RIVERHEAD WATER DISTRICT

**** ADDENDUM NO. 1 ****
SEPTEMBER 22, 2016

Project No.: RDWD 16-02

Project Name: INSTALLATION OF NEW VARIABLE FREQUENCY DRIVES AT PLANT NO. 10 SOUND SHORE ROAD, RIVERHEAD

2 New Single Line Diagram
SCALE: NTS

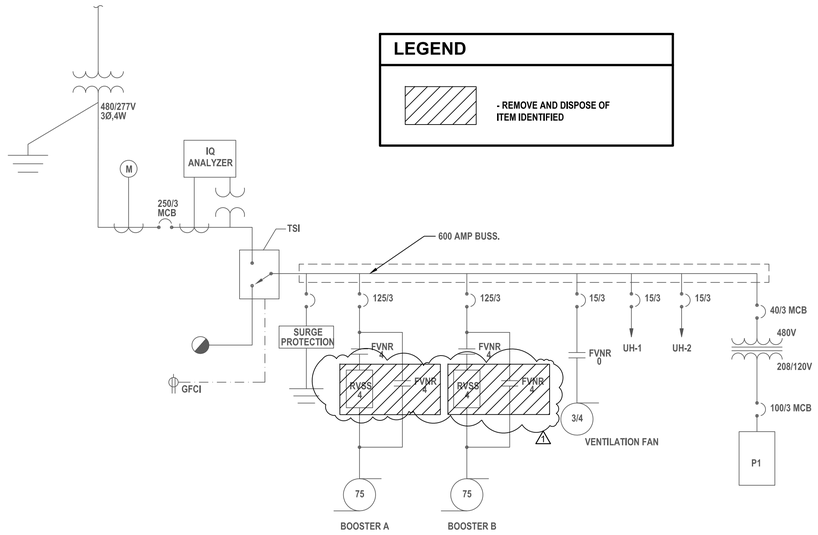
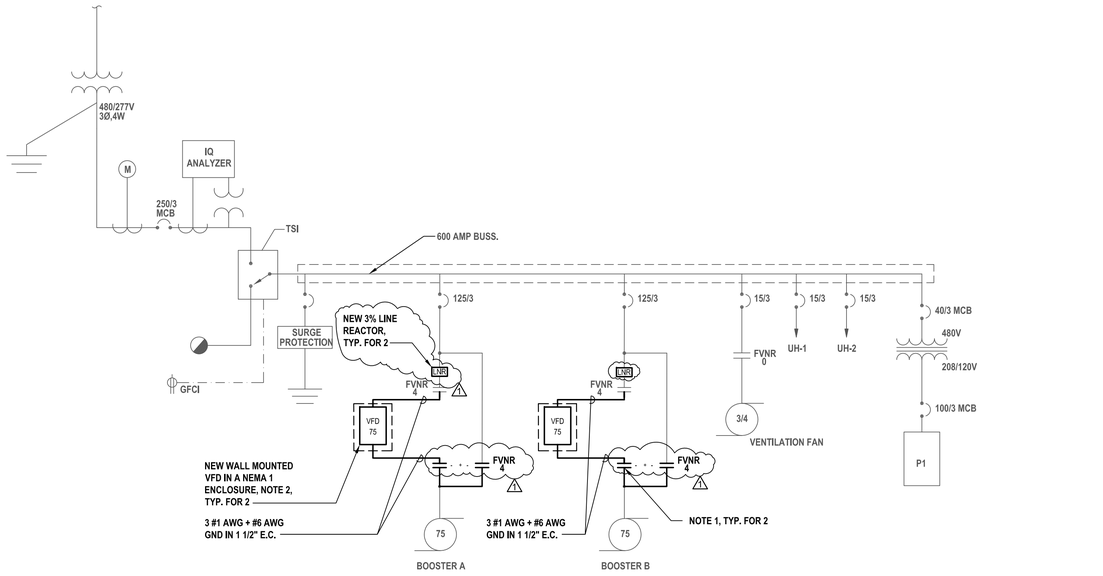
1. Furnish and install a new output and bypass contactor that are factory aligned, mechanically and electrically interlocked.
2. Furnish and install a new line reactor in the existing MCC cubicle.

Contractor shall review revised Sheet E1.0 dated 09.19.2016 for a detailed scope of work required.

1. CONTRACTOR SHALL INSTALL A NEW OUTPUT AND BYPASS CONTACTORS (NEMA 4) IN EXISTING BOOSTER CUBICLE. NEW OUTPUT AND BYPASS CONTACTOR SHALL BE ELECTRICALLY AND MECHANICALLY INTERLOCKED AND SHALL BE INTERFACED WITH NEW VFD. CONTRACTOR SHALL PROVIDE ALL REQUIRED WIRING AND RELAYS.
2. CONTRACTOR SHALL INTEGRATE NEW VFD WITH EXISTING BOOSTER CONTROL CIRCUIT IN EXISTING MCC CUBICLE. CONTRACTOR SHALL PROVIDE ALL REQUIRED COMPONENTS TO INTEGRATE NEW VFD INCLUDING NEW WIRING AND RELAYS AND CONTROLS.
